From: "Robert Henwood" <rahplanning@bigpond.com>
Sent: Thu, 29 Jan 2026 17:12:12 +1000
To: "Maris-Claire Salazar" <maris-claire.salazar@townsville.qld.gov.au>
Cc: "Bruce Kingsun" <admin@kingsunproperties.com.au>; "Tony Parker" <tony@imcommercial.com.au>
Subject: RFI - 325 Shaw Road Shaw 4818 - Lot 19 SP107219
Attachments: 25-391 site plan - 28-01-2026.pdf, 01_TIA_Shaw.pdf, SK06-09_27.08.2025.pdf

Application no: MCU21/0089.03

Proposal: Change Other to Development Approval associated with MI16/0015

Street address: 325 Shaw Road SHAW QLD 4818

PRELIMINARY		JOB No. // DRAWING No.	
NOT FOR CONSTRUCTION		KIN0323-01//	
		SK06	
DATE	*Scale (A3)	PREPARED FOR	
27.08.2025	As shown	For Discussion

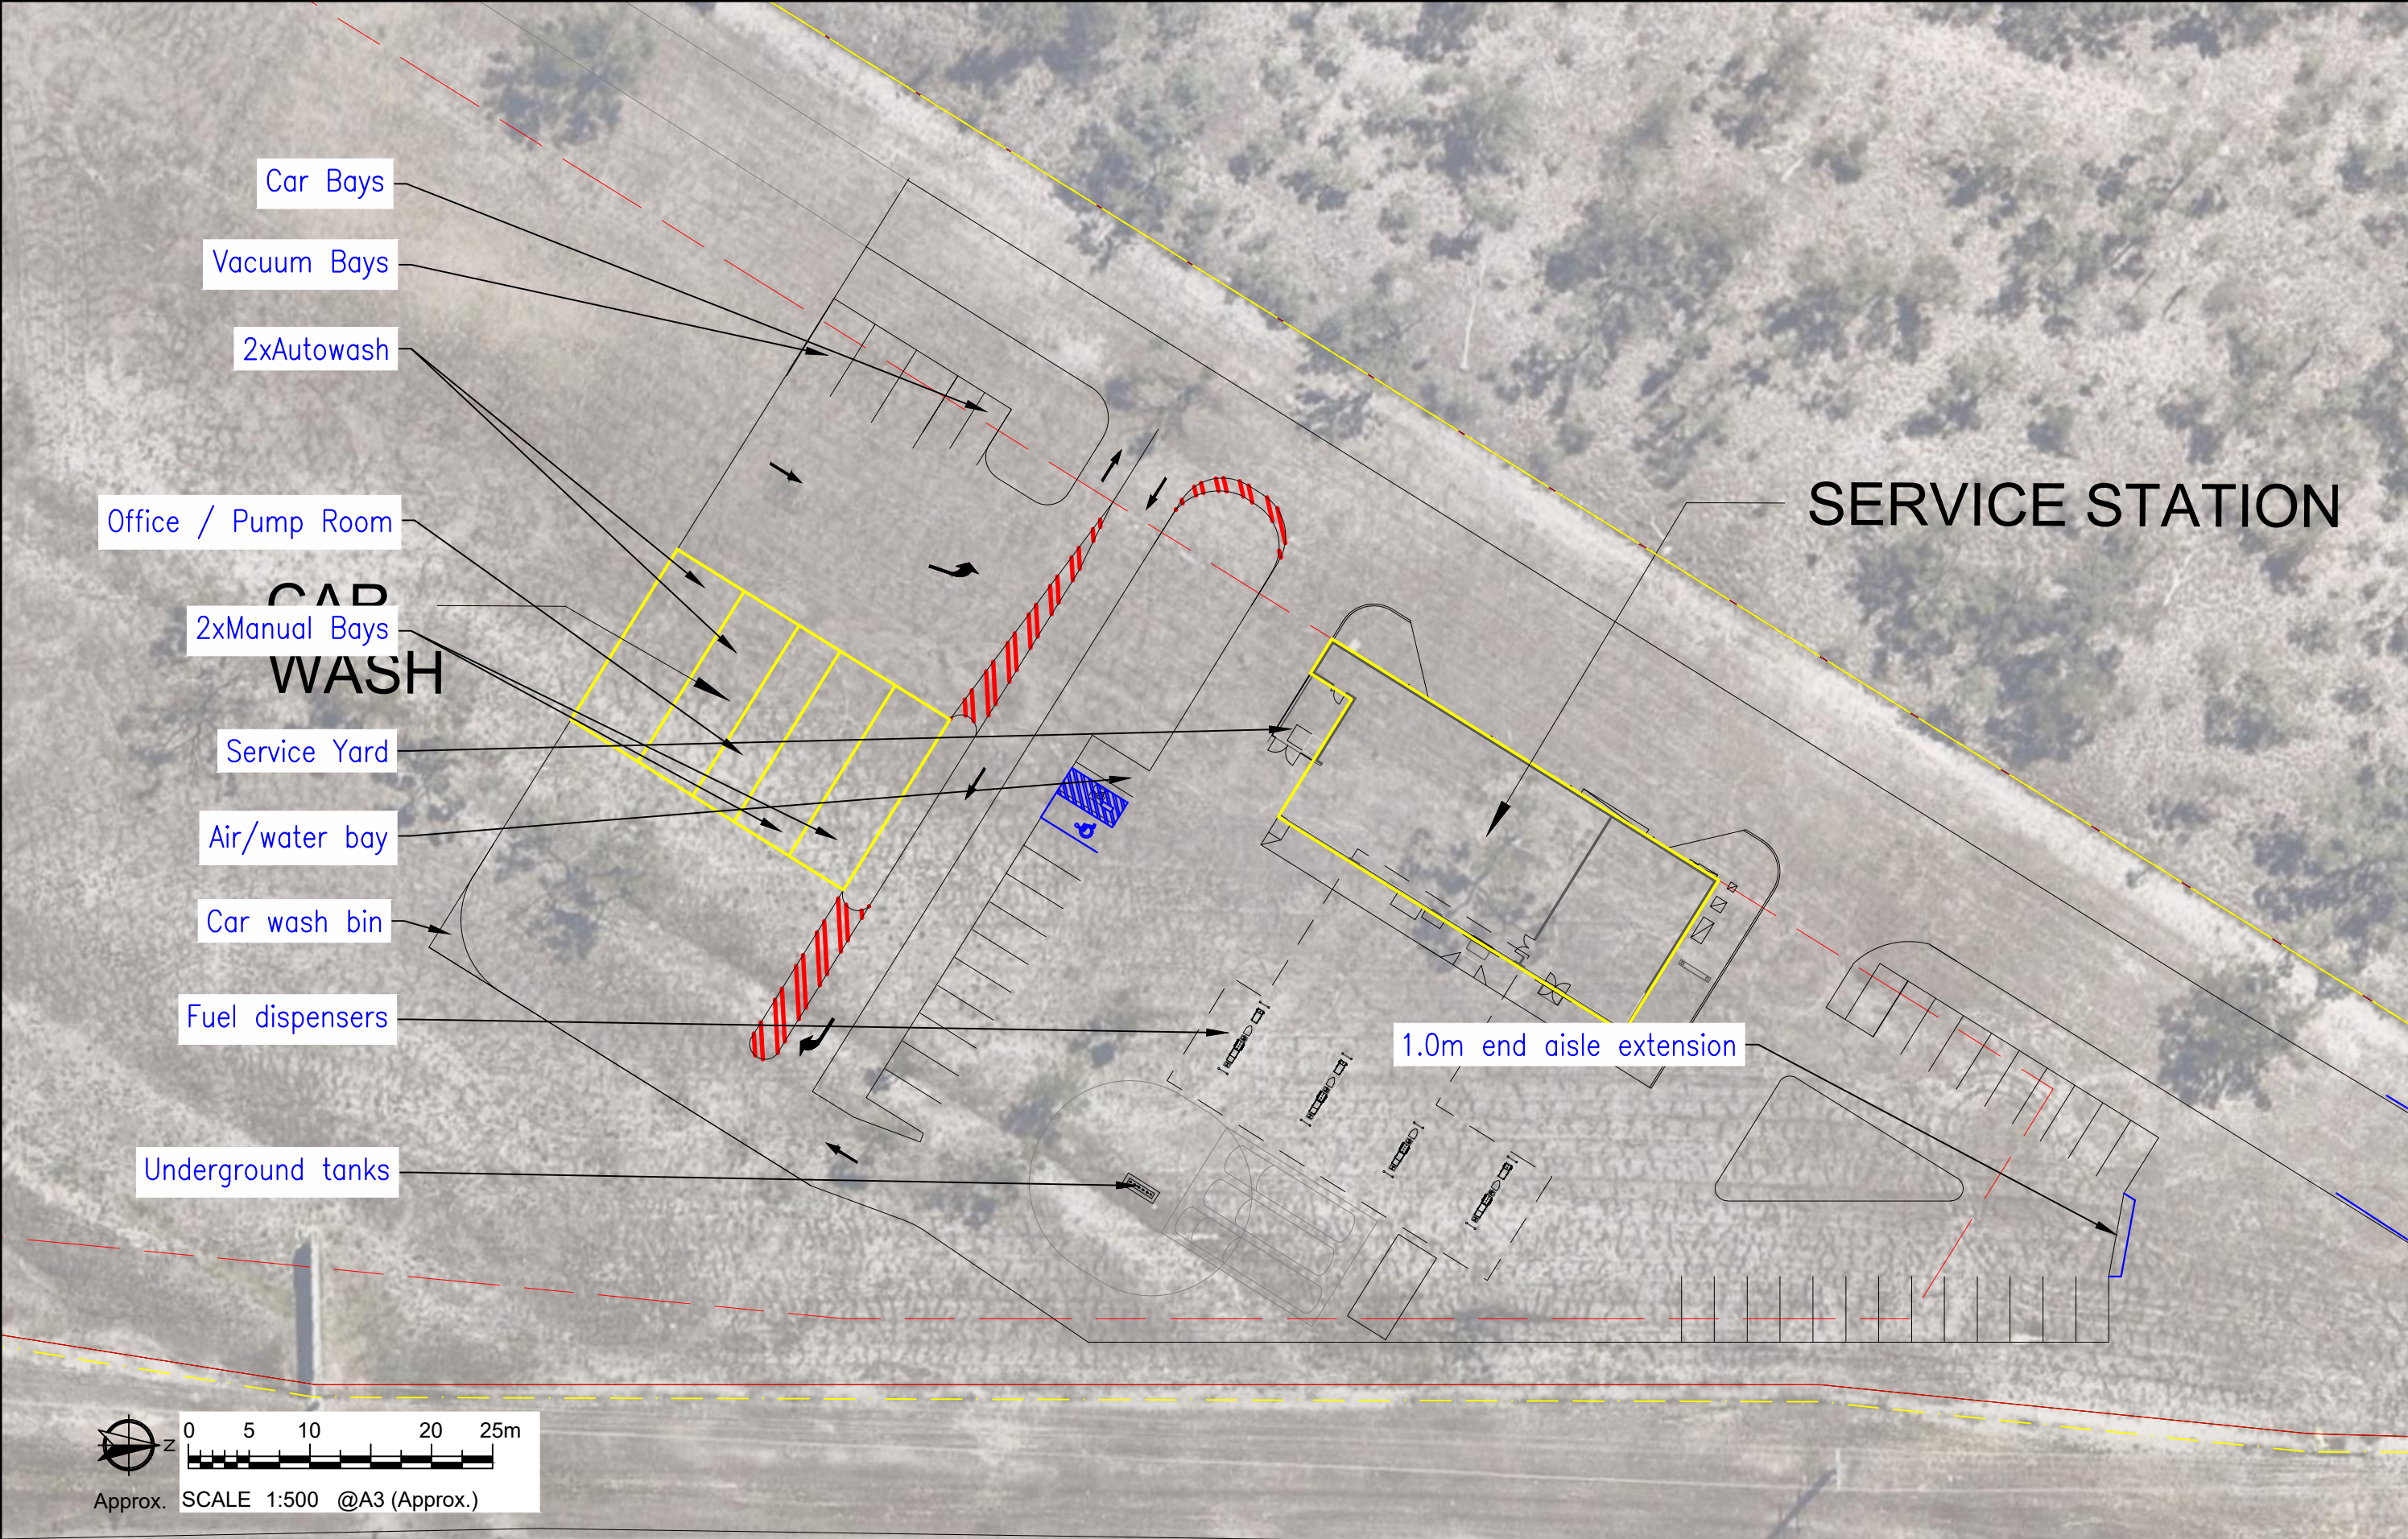
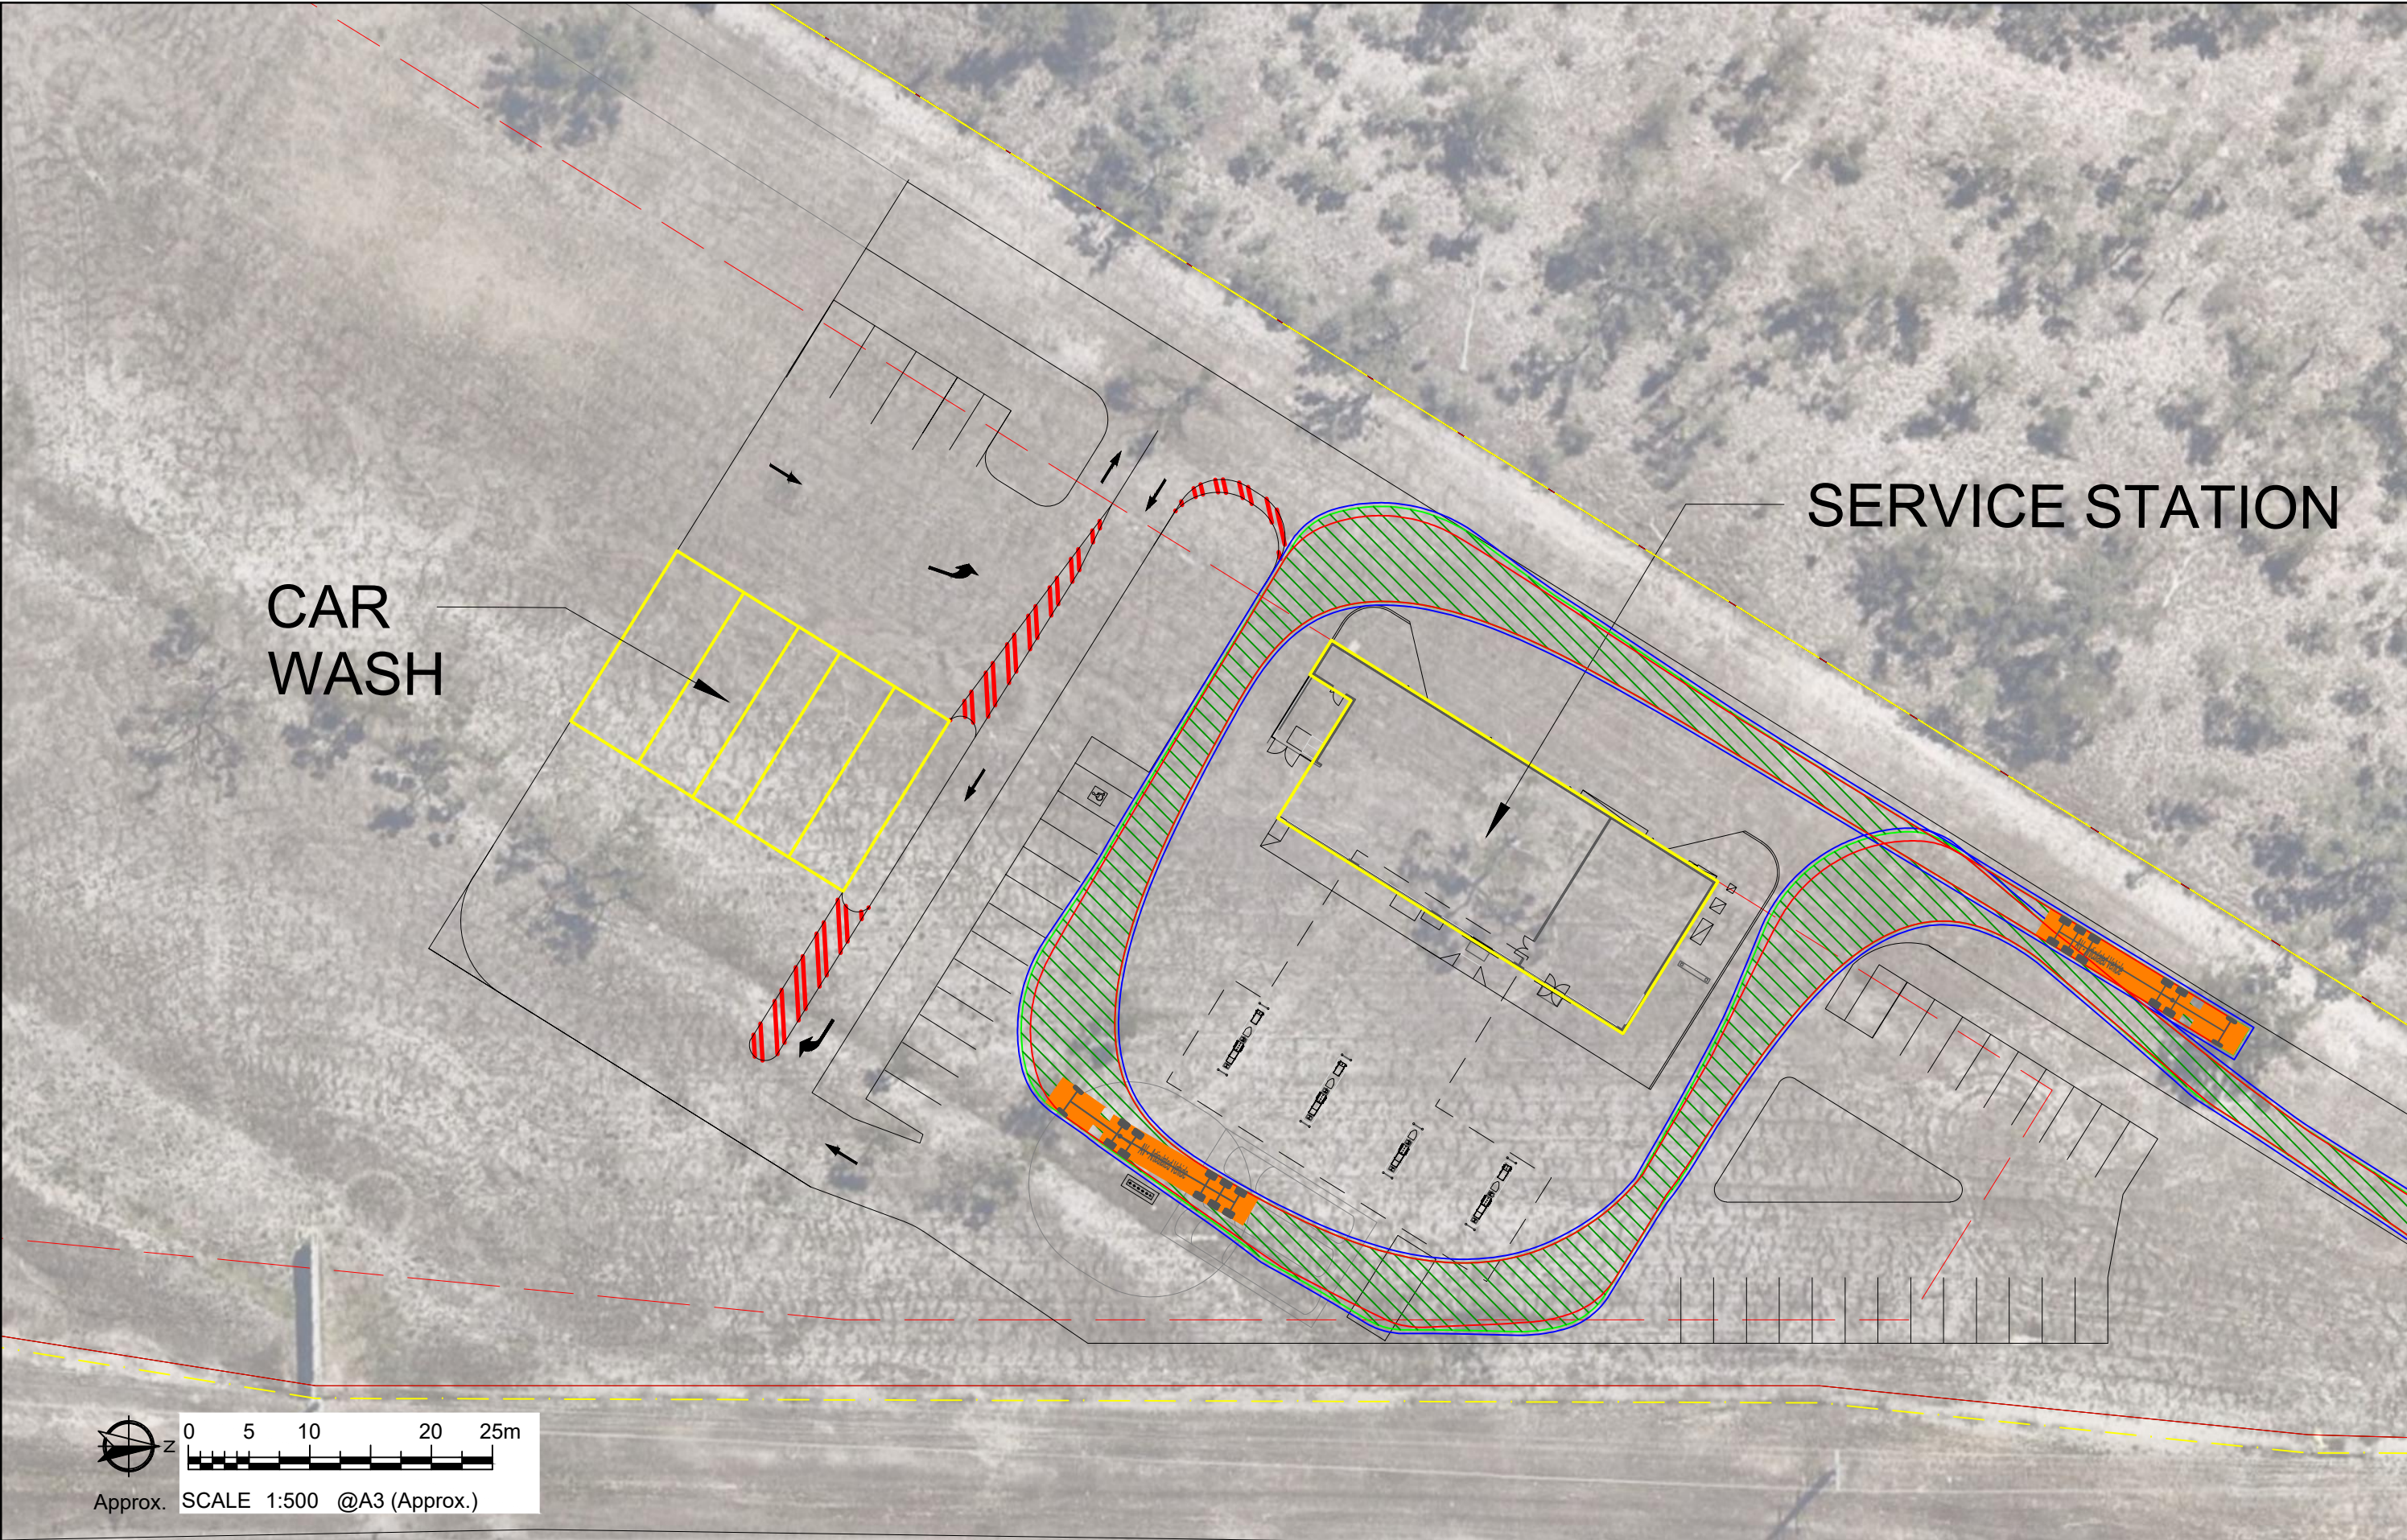
Request Item 3 – Amended Traffic Impact Assessment

The applicant is requested to provide an amended Traffic Impact Assessment to include swept path assessments for all car wash bays.

Attached are the amended Traffic Impact Assessment report and drawings prepared showing the Swept paths to car wash bays etc
